Access Compliance Report Public Rights-of-Way (Curb Ramps)

Main Street: CORTESE_DR Cross Street: WEATHERBY_RD Location: NW

ADA ID: RPRK211217132838 Ramp Type: Type 4 - Parallel Initial Pass/Fail: Fail Overall Compliance: No Severity Score: 2

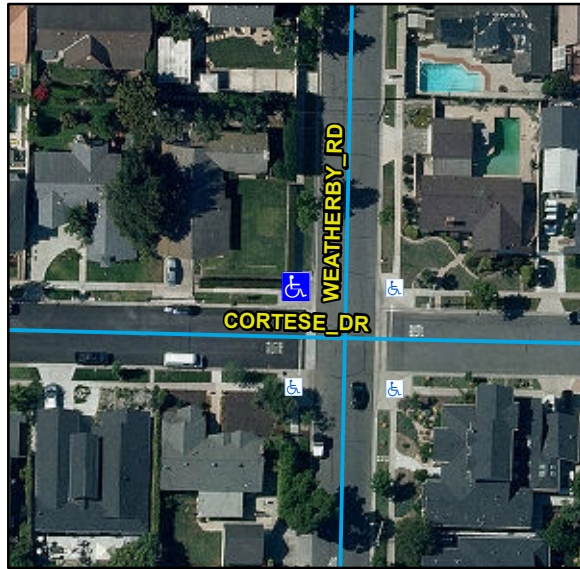
Compliance	Description	Data	Compliance	Description	Data
N/A	Ramp Length LT (in)	100	N/A	Ramp Length RT (in)	92
Yes	Ramp Width LT (in)	94	Yes	Ramp Width RT (in)	92
Yes	Ramp Run Slope LT (%)	6.5	Yes	Ramp Run Slope RT (%)	7.2
No	Ramp Cross Slope LT (%)	2.4	Yes	Ramp Cross Slope RT (%)	1.7
N/A	Landing Present	N/A	N/A	DWS Provided	N/A
N/A	Landing Length (in)	N/A	N/A	DWS Contrast	N/A
N/A	Landing Width (in)	N/A	N/A	DWS Length (in)	N/A
N/A	Landing Run Slope (%)	N/A	N/A	DWS Full Width	N/A
N/A	Landing Cross Slope (%)	N/A		DWS Offset Type	N/A
N/A	Landing Movement Obstructed?	N/A	N/A	DWS Offset Left (in)	N/A
	Landing Movement Type	N/A	N/A	DWS Offset Right (in)	N/A
N/A	Landing Shared	N/A			
N/A	Clear Space	Yes			
N/A	Clear Space To Crosswalk (in)	N/A			
N/A	Marked Crosswalk 1	No	N/A	Marked Crosswalk 2	No
	Crossing 1 Direction	S		Crossing 2 Direction	E
	Marked Crosswalk 1 Width (in)	N/A		Marked Crosswalk 2 Width (in)	N/A

Remove & Replace Curb Ramp With Two New Directional Ramps or Equivalent.

R304.5.3, STD 1115
